## ***Interactive comment on “Evaluation of Low Impact Development and Nature-Based Solutions for stormwater management: a fully distributed modelling approach” by Yangzi Qiu et al.***

**Yangzi Qiu et al.**

Received and published: 18 September 2019

Figure 1: Presentation of the simulated hydrographs in whole catchment and in three sub-catchments (a: whole catchment, b: SUB1, c: SUB2, d: SUB3) for the scenario of baseline and porous pavement for the event 05/10/2015.

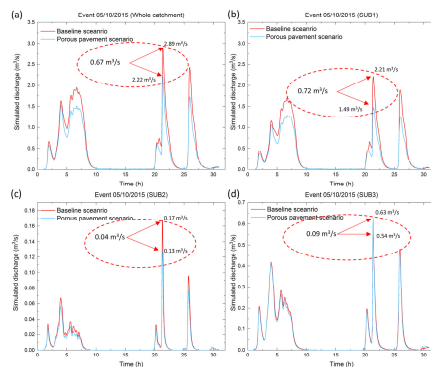
Q1- Uncertainty of the model, the simulations, model structure, X-band radar, down-scaling etc etc. . . the values and ratio, how can 0.1 cms change be really evaluated given the total discharge.

Firstly, the 0.1 cms can absolutely be simulated by Multi-Hydro, whose accuracy is better than  $1.5 \times 10^{-4}$  cms.

Secondly, the 0.1 cms discharge difference between the porous pavement scenario and baseline scenario at the highest rainfall peak of event 05/10/2015 in the sub-catchment (SUB3) is small, but nevertheless represents about 20% of the peak of the baseline scenario and not negligible with respect to those of the largest sub-catchment SUB1 and of the whole catchment. Indeed, they involve factors in the range of 4-7 (see more details in Fig.1, enclosed).
